ADDENDUM NO. 8

**DELAWARE STATE UNIVERSITY (OWNER)
OPTICAL SCIENCE CENTER FOR APPLIED RESEARCH
Contract Nos.:
PC-2014-006A-OSCARPAINT (Paint)
PC-2014-006B-OSCARIT (I.T. Cabling)
1220 N. DuPont Highway
Dover, DE 19901**

Addendum Number: 08

Delaware State University
Optical Sciences Center for Applied Research
Date: June 12, 2014

SKE-018

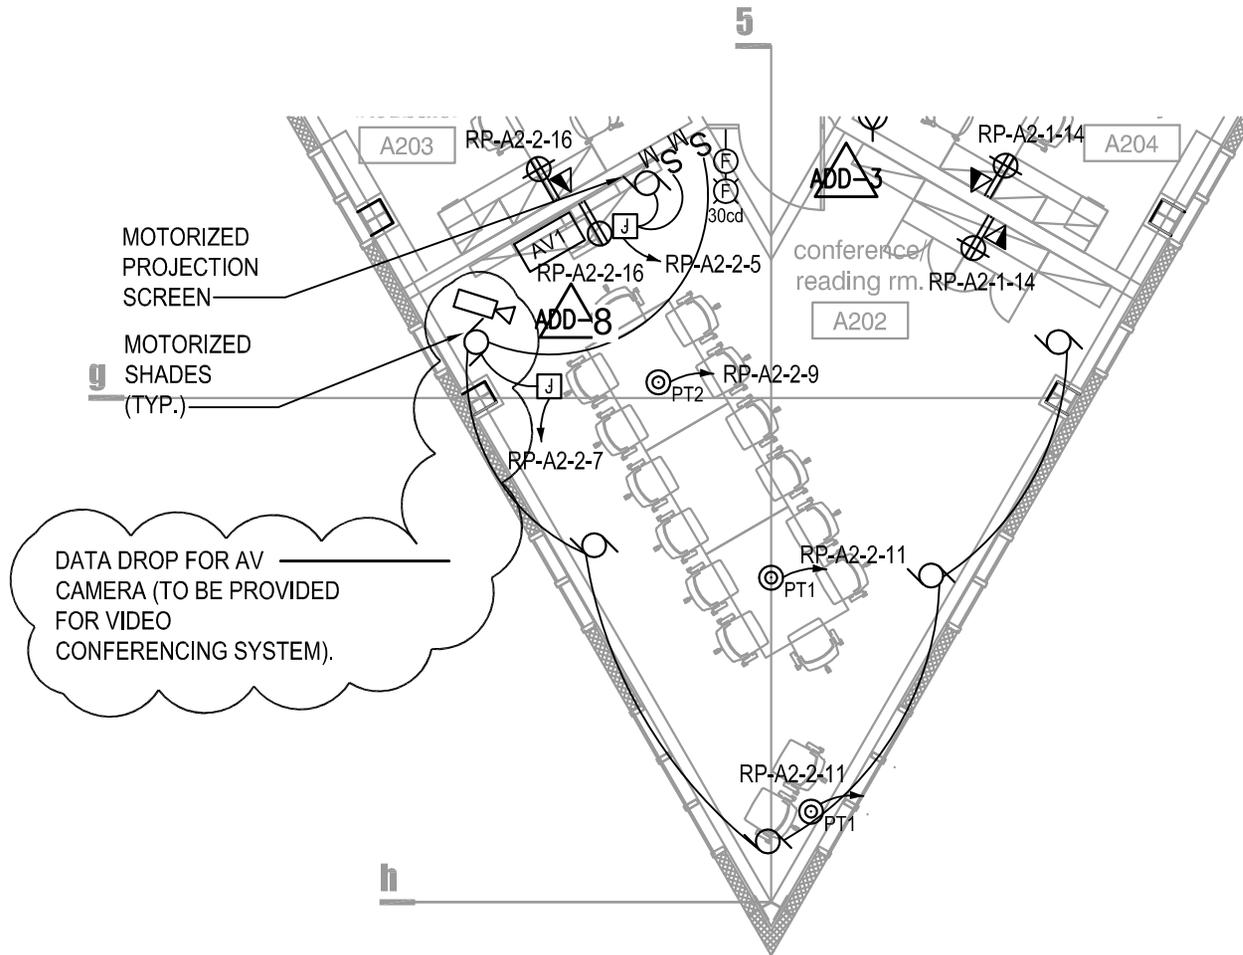
1. Per attached sketch **SKE-18**- function for camera at rear of seminar room A103 clarified
2. Per attached sketches **SKE-19 and SKE-20** – location of camera to be used for teleconferencing added to conference room on levels 2 and 3.
